49 CFR Part 572

Anthropomorphic Test Devices; Hybrid III 5th Percentile Female Test Dummy, Alpha Version; Final Rule; Response to Petitions for Reconsideration

ACTION: Final rule; response to petitions for reconsideration.

FIGURE O1
NECK FLEXION TEST SETUP SPECIFICATIONS

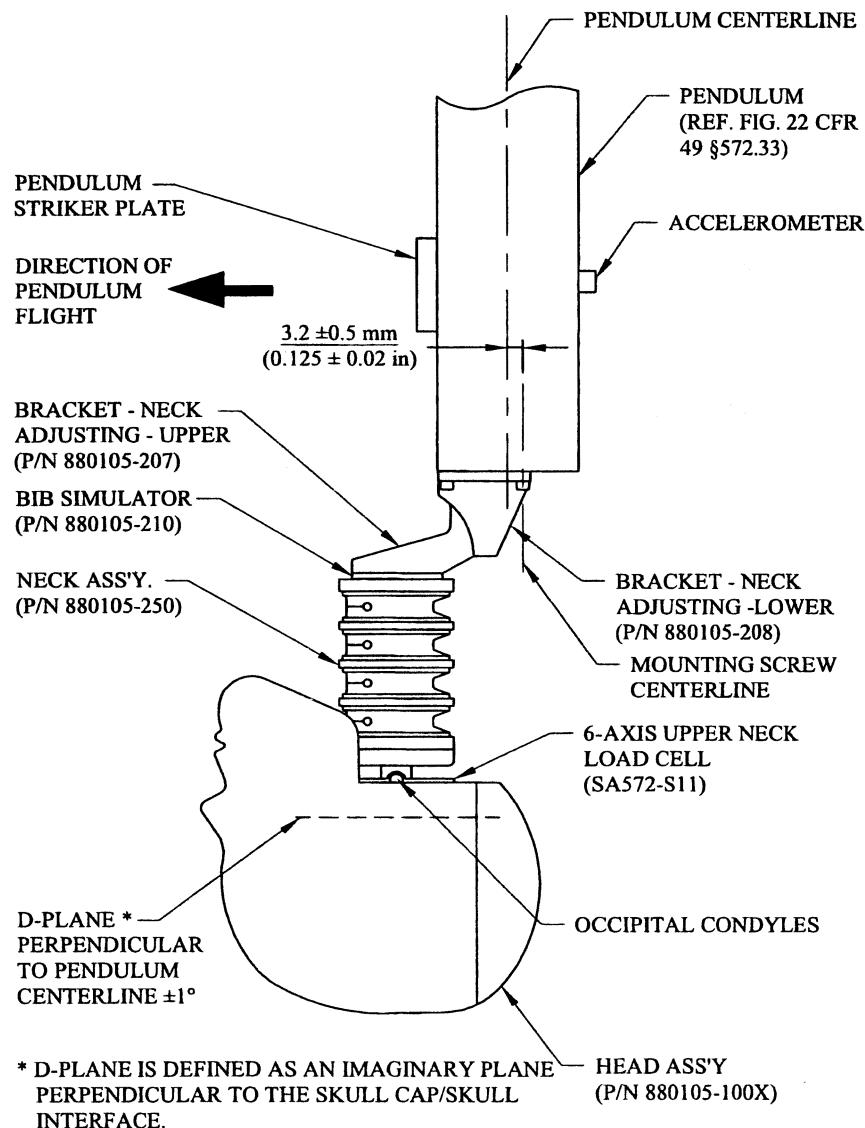
The Alliance noted that Figure O1 (*Neck Flexion Test Setup Specifications*) is missing the label for the lower neck-adjusting bracket. The Alliance also noted that the second label for the neck-adjusting bracket in Figure O2 (*Neck Extension Test Setup Specifications*) is incorrect. It should read: “BRACKET—NECK ADJUSTING—UPPER (P/N 880105–207).”

NHTSA agrees with all of these recommendations. The suggested changes reflect errors in the figures. Accordingly, the agency is revising Figure O1 by adding the missing label for the lower neck-adjusting bracket. That label will read “BRACKET—NECK ADJUSTING—LOWER (P/N 880105–208).” The agency is also revising the second label for the neck-adjusting bracket in Figure O2 to read: BRACKET—NECK ADJUSTING—UPPER (P/N 880105–207). The agency is changing the tolerance for the test probe alignment in Figure O3 from ± 0.05 degrees to ± 0.5 degrees, and the tolerance for the impact probe weight in Figures O3 and O5 from ± 0.01 kg (0.02 lb) to ± 0.023 kg (0.05 lb). Finally, the agency is adding the angle 7 ± 2 degrees from the horizontal to the note *Pelvic Angle Reference Surface* in Figure O3.

FIGURE 04
TORSO FLEXION TEST SET UP SPECIFICATIONS

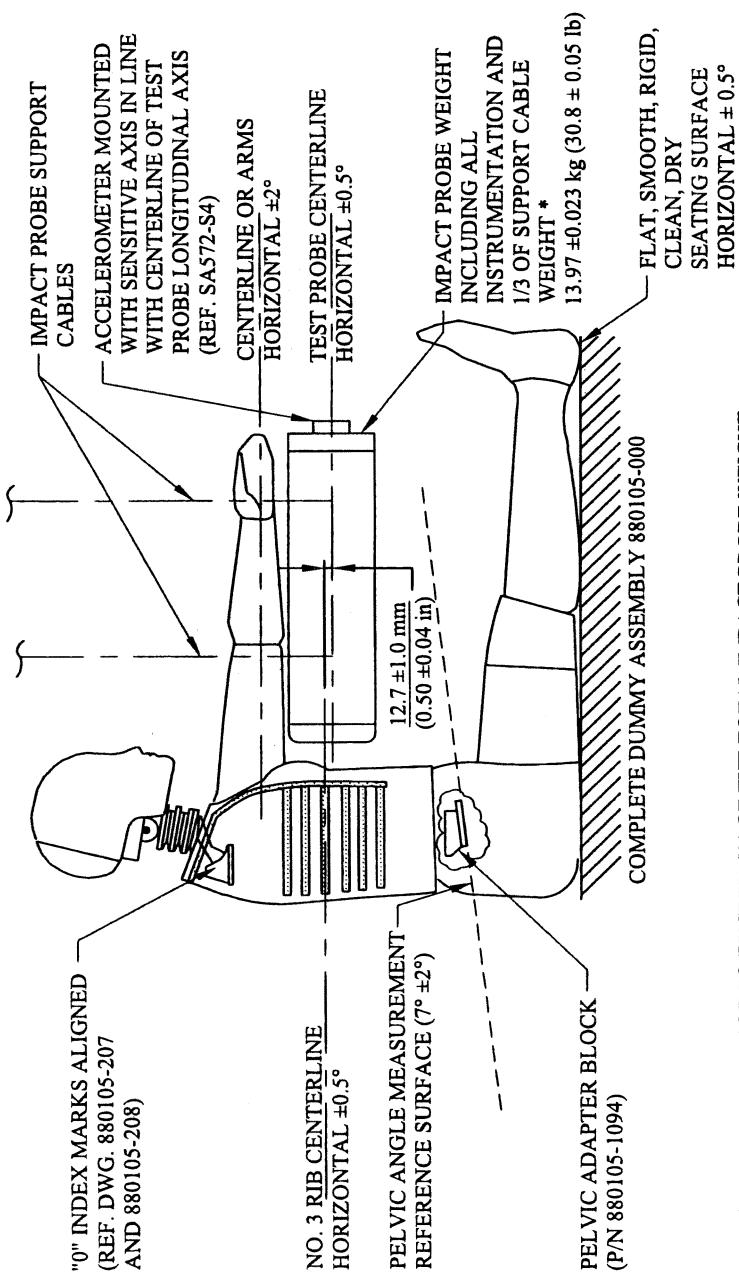
In reviewing Figure O4, NHTSA discovered that it had failed to specify the weight of the pull mechanism⁷ used in the torso flexion test. The Hybrid III Six- and Three-Year-Old dummy requirements each specify the weight of the pull mechanism for the torso flexion test. To be consistent with those dummy requirements and assure test repeatability, the agency is specifying that the weight of the pull mechanism must be less than or equal to 1.07 kg (2.35 lb).

Accordingly, the agency is adding the following note to Figure O4: “Combined weight of load cell, loading adaptor bracket, pull cable, and attachment hardware 1.07 kg (2.35 lb).
